ADDENDUM NO. 1

Franklin Street Improvement (CIP T-138)

ADDENDUM NO. 1 – DATE: June 17, 2019

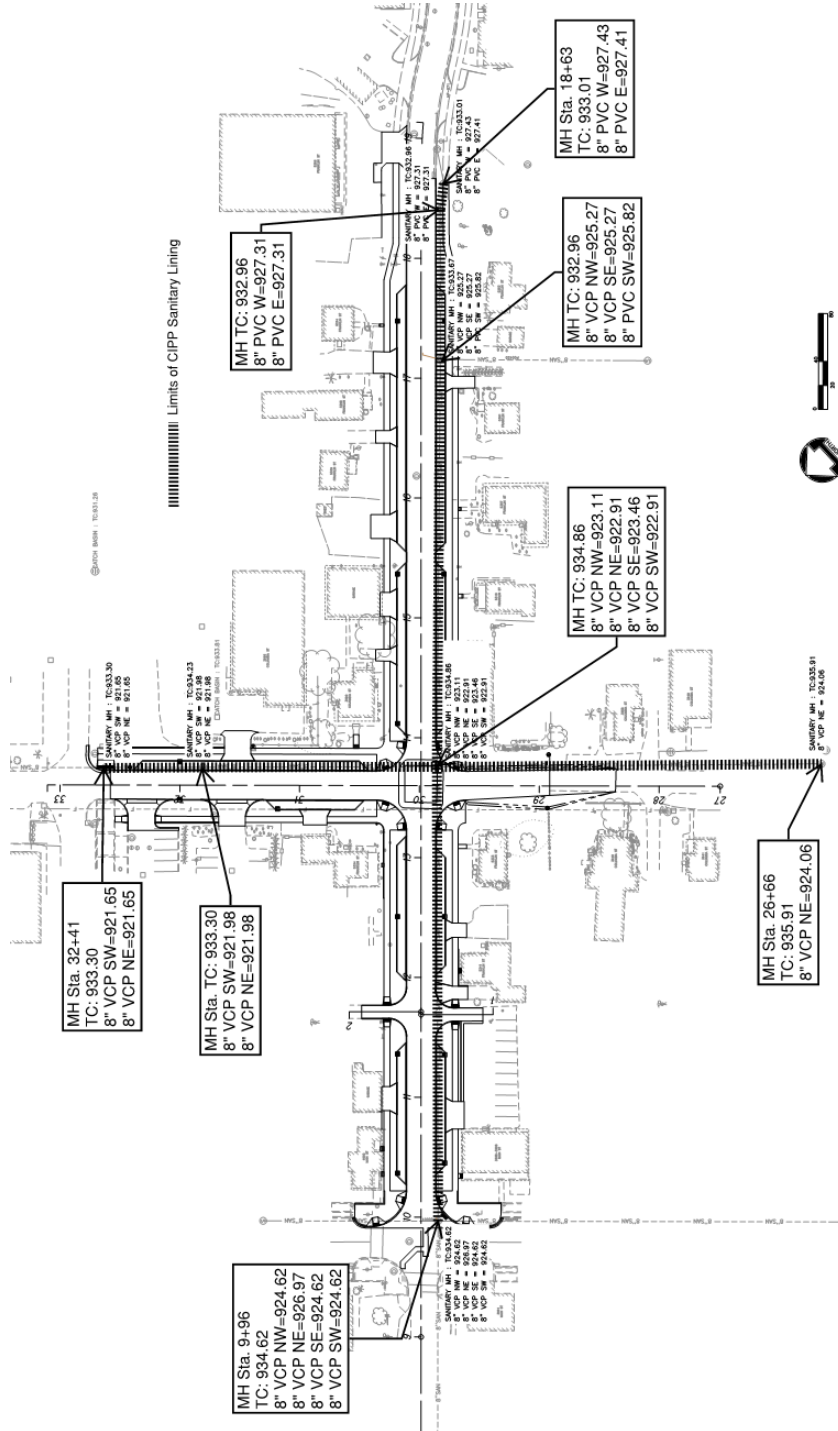
The attached exhibit illustrates the extents of the CIPP lining as well as lists the existing invert information. The lining is from Franklin St: Sta 9+96 to Sta 18+63 = 867 LF; Columbia St: Sta 26+66 to Sta 32+41 = 575 LF.
